SAN FRANCISCO PLANNING DEPARTMENT

Memo to the Planning Commission

Date: April 6, 2017
Case No.: 2014.0086DRP-02
Project Address: 2855 FILBERT STREET
Building Permit: 2013.10.04.8576 (New Construction)
Zoning: RH-1 (Residential House, One-Family) District
40-X Height and Bulk District
Block/Lot: 0948/029
Project Sponsor: Stephen Sutro
Sutro Architects
1055 Post Street
San Francisco, CA 94109
Staff Contact: Brittany Bendix – (415) 575-9114
Brittany.bendix@sfgov.org
Recommendation: **Take DR and Approve with Modifications**

The following are the agreed to changes to the 311 plans dated August 24, 2016:

PROPOSED SECOND FLOOR PLAN

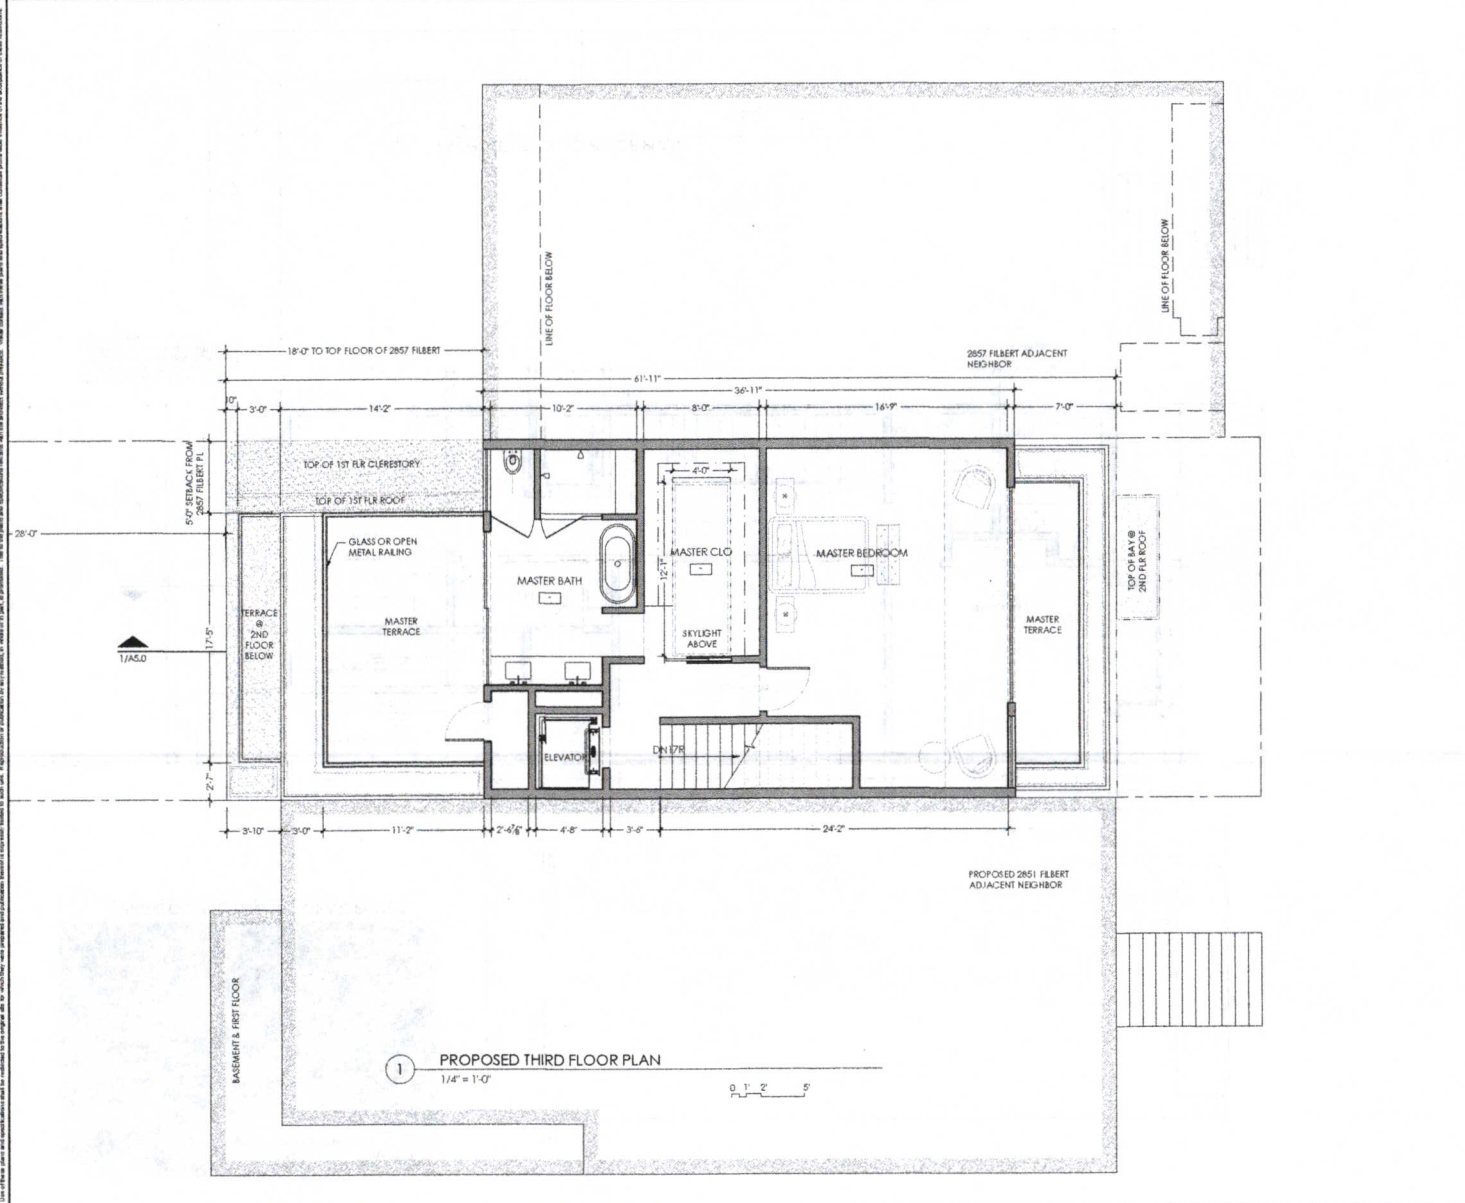
LOW METAL EDGE PLANTER @ 12" AFF.
NOTE: PRAIRIE DROPSEED NATIVE GRASSES APPROX. 2-4 FEET HIGH WHEN MATURE ABOVE FINISH SECOND FLOOR. SEE PHOTO FOR SPECIES INFO.

PROPOSED ROOF PLAN

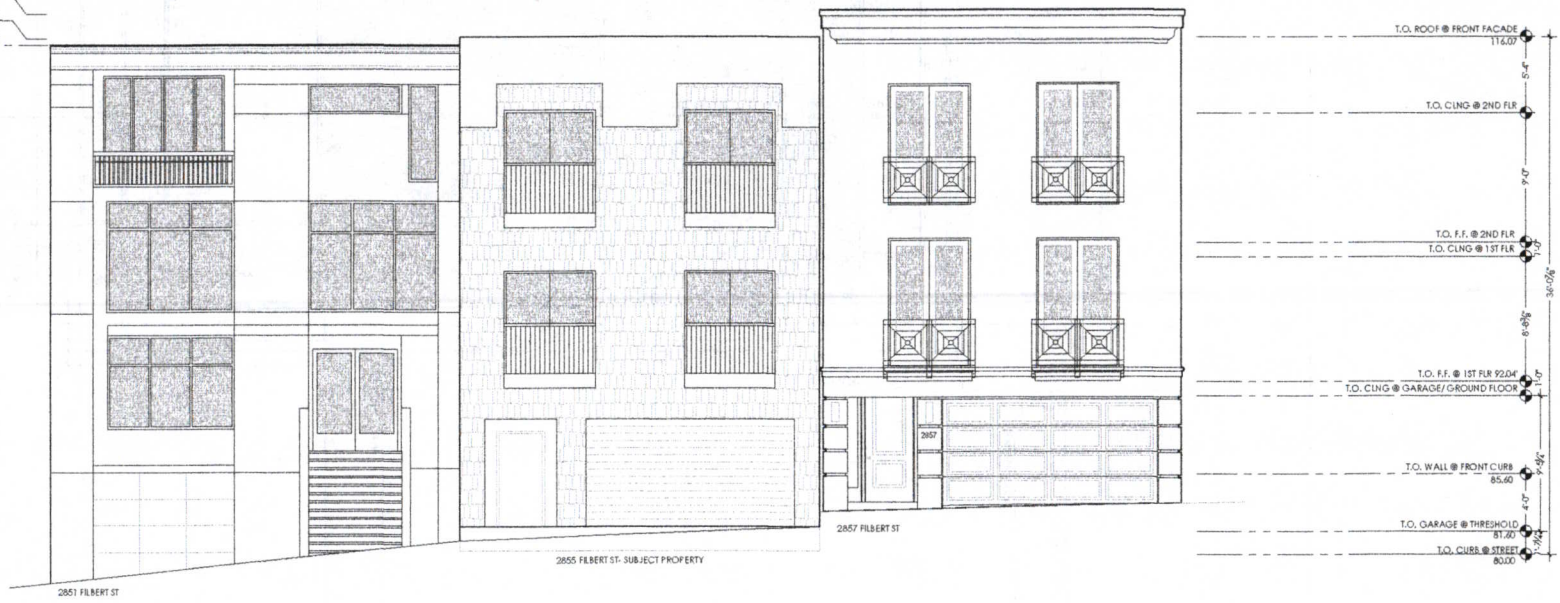
1. The top floor roof will be changed in the following ways:
 - a. The roof shall be flat, with one middle section 20' long (N-S) at an elevation (measured at the top of roof curb) no higher than 121.0 SF datum (41 feet above curb) and the lower portions no higher than an elevation of 120.3 SF Datum (40.3 feet above curb). The one middle section referenced above could be made smaller to accommodate a skylight such that the skylight and middle section combined would not exceed the footprint of the 20' long section. There will be no appurtenances (skylights, etc.) rising above the maximum limits of each section except customary vents and solar panels (as outlined in the Agreement). The foregoing shall not prohibit standard roof construction methods necessary to create a proper drainage slope provided that at no point shall the roof (including curbs, roofing material, etc...) exceed the maximum height of each section. Additionally, skylights shall be constructed and installed such that they do not exceed these height limits at their peak, and they are located a sufficient distance from the property line(s) so as not to require a parapet.

- b. Eliminate the downward-sloped roof segments that are adjacent to the dormer pop-out shown in the front of the building on 311 drawings. The entire front portion of the roof will be flat, and will extend across the entire width of the property.
